Region 10 Enforcement and Compliance Assurance Division
1200 6th Avenue
Seattle, WA 98101
INSPECTION REPORT

Movado Subdivision No. 5, 7, and 9
Construction Stormwater Inspection Report

Inspection Date: February 25, 2021

Photograph 1. View, facing southwest, of a soil stockpile located on the northwestern perimeter of Phase 5 on a roadway. The stockpile did not have a sediment barrier installed downgradient. Note the track out surrounding the soil stockpile.

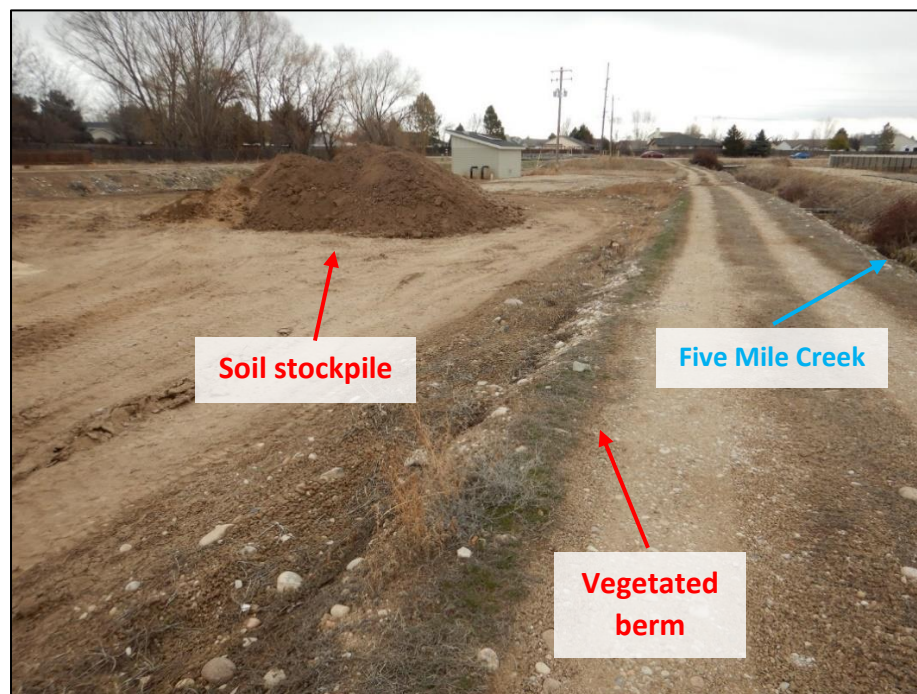
We observed an uncontained soil stockpile along the northwest perimeter of the Site in Phase 5 adjacent to an impervious area. The stockpile appeared to contribute to sediment track-out onto the pavement around it and lacked sediment barriers along the downgradient perimeter areas of the roadway (refer to Attachment A, Photograph 1).

We also observed sediment track-out around the soil stockpile located on the northwestern perimeter of Phase 5 on a roadway and the gravel and soil stockpile located on the eastern portion of the Site in Phase 7 on South Movado Way (refer to Attachment A, Photographs 1 and 3).

Photograph 4. View, facing west, of a pile of construction waste and debris in an uncovered plywood container located on the northern perimeter of Phase 5 in lot 80.

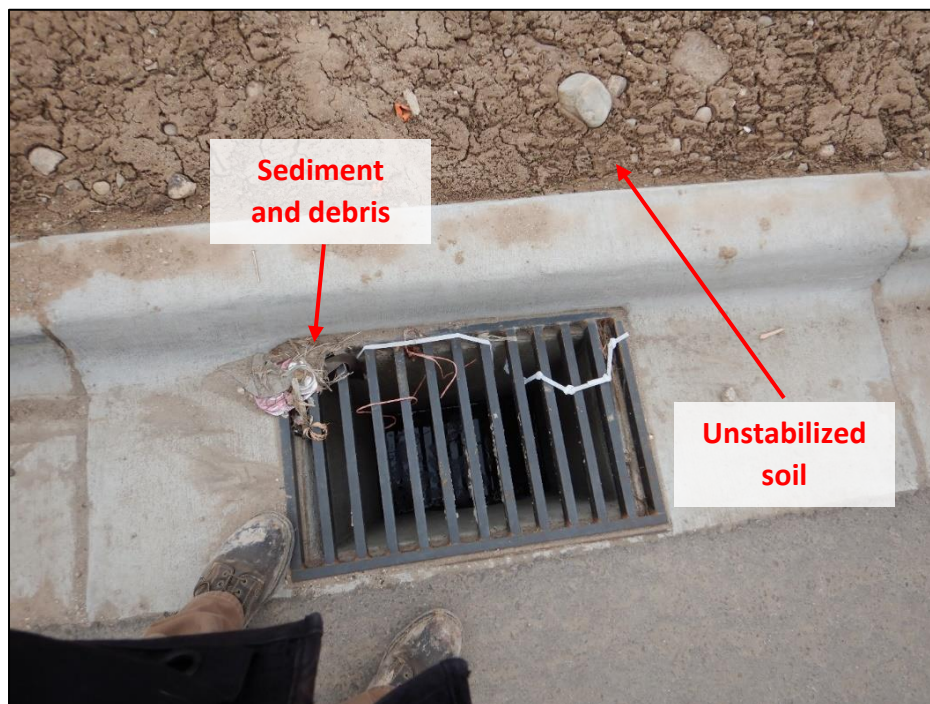
We observed construction waste and debris in an uncovered plywood container outside home building site lot 80 in Phase 5. Additionally construction waste was observed on the ground adjacent to the plywood container (refer to Attachment A, Photograph 4).

Photograph 6. Another view, facing south, of sediment and debris collected adjacent to a storm drain inlet and unstabilized exposed soil located along a roadway at the north-central perimeter of Phase 5. No BMP inside the inlet was observed.

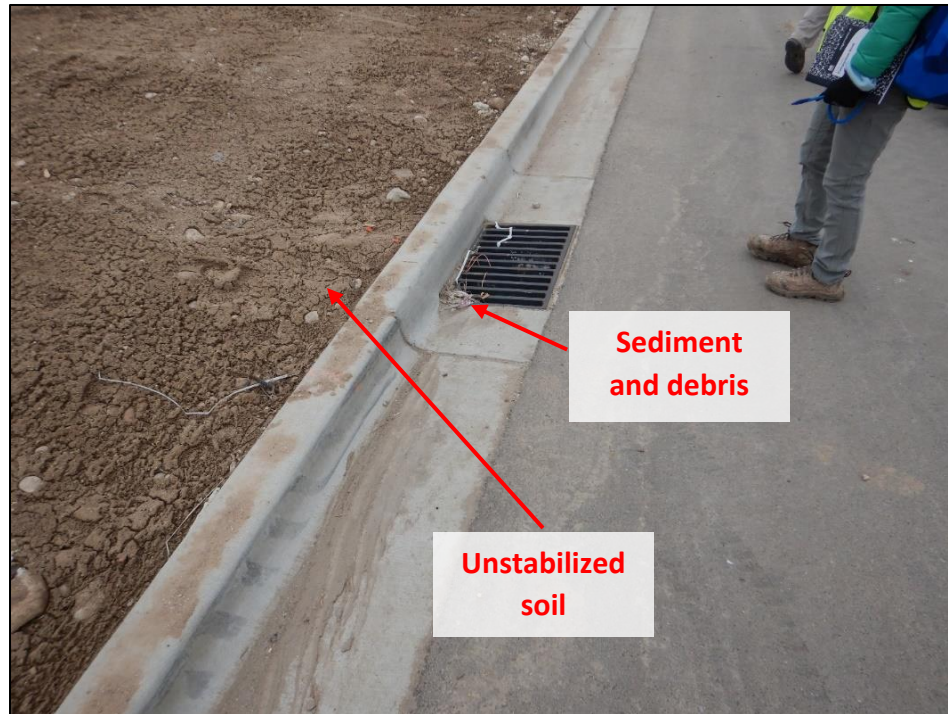
We observed sediment and debris and unstabilized soil adjacent to a storm drain inlet located on a paved roadway along the north-central perimeter of Phase 5. The storm drain inlet discharges to two seepage beds in Phase 5. We did not observe any inlet protections inside the storm drain inlet (refer to Attachment A, Photographs 5, 6, and 7).

Exhibit 4. Image of the Site map of Phases 7 and 9 provided on Site of Movado Subdivision No. 5, 7, and 9. It was noted that the Site map does not identify all locations of stockpiles.

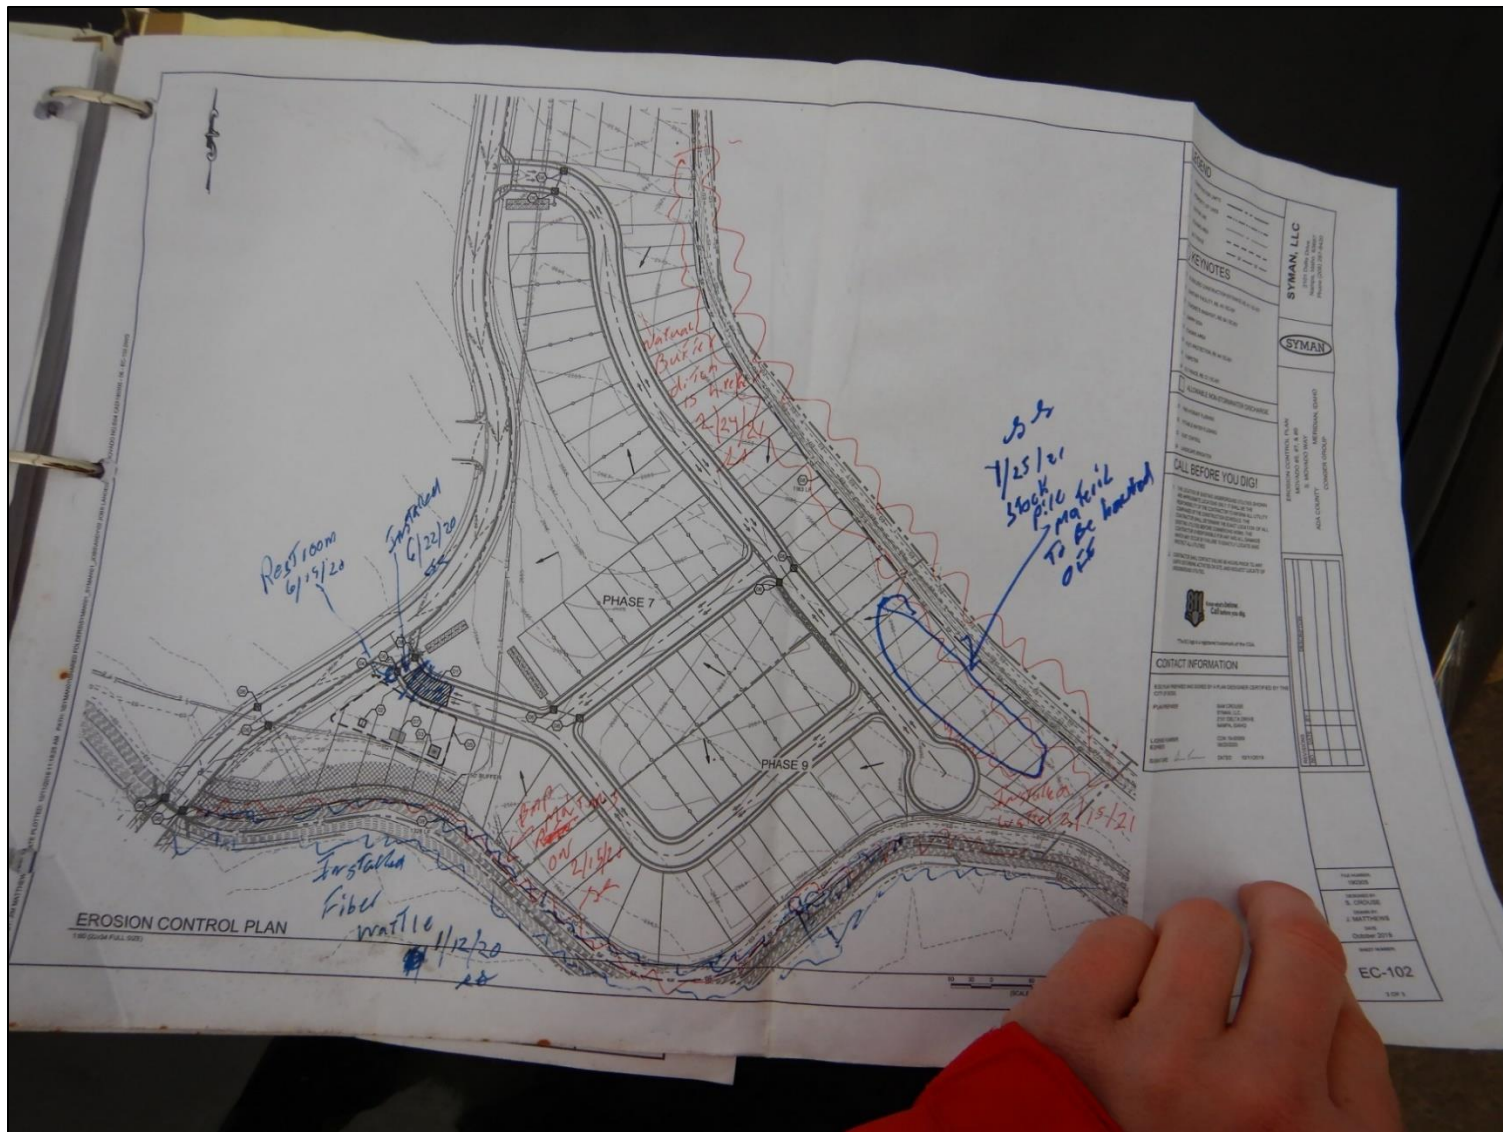
During the onsite records review, we observed that the SWPPP map presented on Site did not include every location where sediment and soil would be stockpiled as required by Part 7.2.4.b.iii of the Permit. The Site had three locations where soil and gravel were stockpiled – one at the northwestern perimeter in Phase 5, one along the western perimeter of Phase 7, and one along the eastern area of Phase 7 (refer to Attachment A, Photographs 1, 2, and 3). The onsite SWPPP map depicted an area where soil would be stockpiled, but the stockpiles were observed to be outside of that area (refer to Attachment B, Exhibit 3 and 4).
